FORD 4R100 "UPDATE HANDBOOK"

FORD 4R100 "UPDATE HANDBOOK"

Since the introduction of the 4R100 transmission in model year 1998, there have been many engineering changes to improve Pleaseability, Reliability and Durability concerns. These changes have affected most every part used in this transmission. This "Update Handbook" will explain each change, the reason for the change, and any parts interchangeability concerns created by the change, along with any part numbers needed to update your transmission.

Figure 78

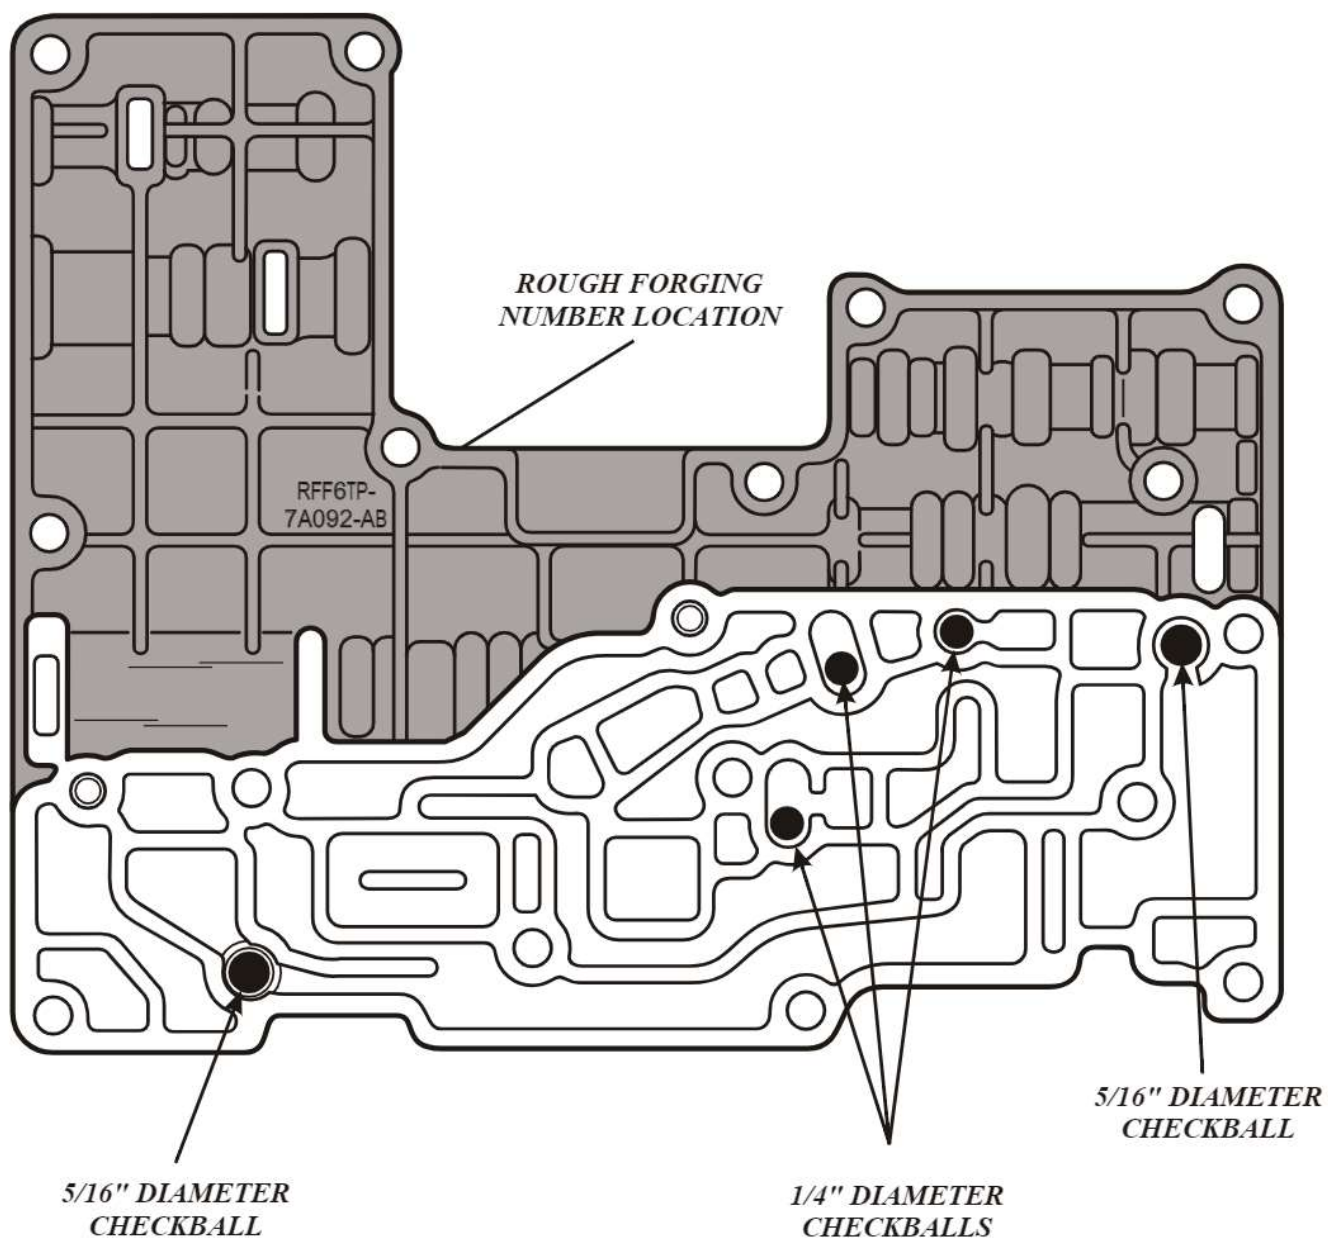
- (7) EXTENSION HOUSING - A4R100 style with boss in the extension housing to retain the lube plug in the new design case, as shown in Figure 76.
- (8) MAIN VALVE BODY - Requires 1996 hydraulics which is identified by RF-F6 cast into the valve body, in location shown in Figure 77, and checkball locations are shown in Figure 78.

VALVE BODY CHECKBALL LOCATIONS
REQUIRES THREE 1/4" RUBBER BALLS,
AND TWO 5/16" RUBBER BALLS

Figure 79

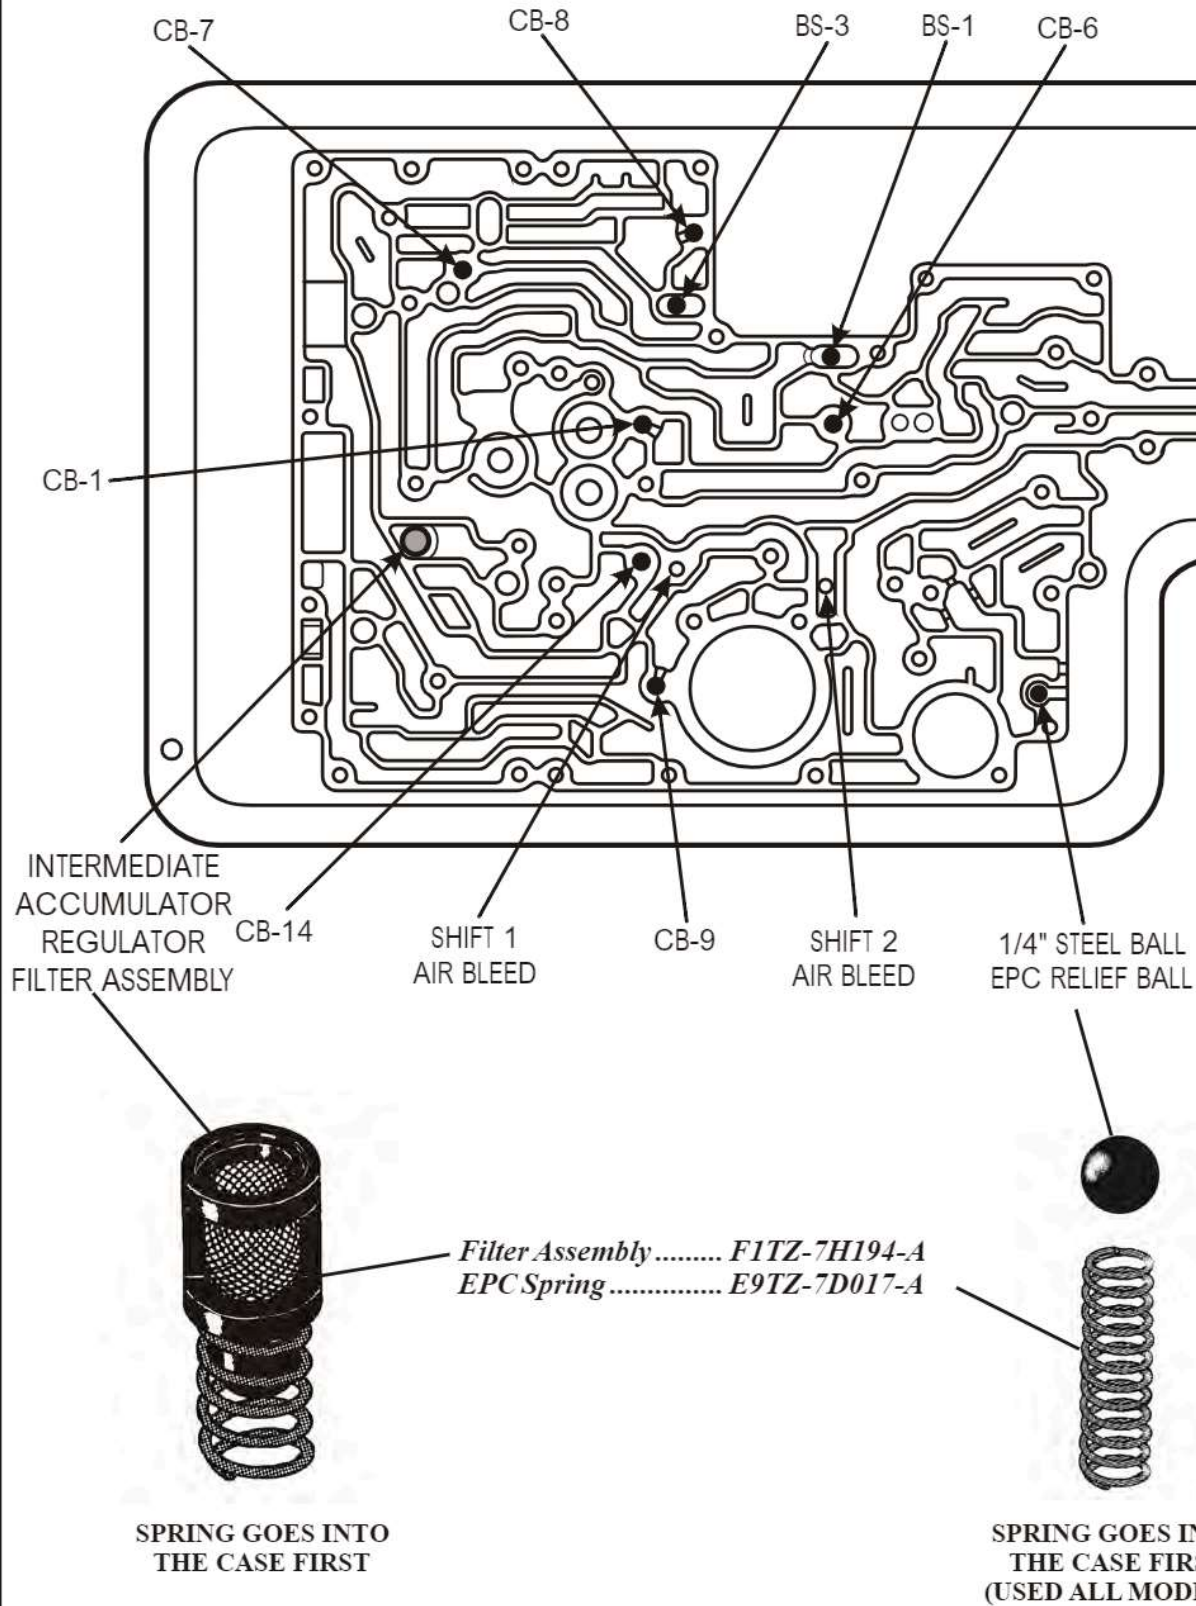
- (12) CASE CHECKBALL LOCATIONS - Requires the 1996 and later case checkball locations, which is eight checkballs in locations shown in Figure 79.

4R100 "MODIFIED" CASE CHECKBALL LOCATIONS REQUIRES EIGHT (5/16") RUBBER BALLS
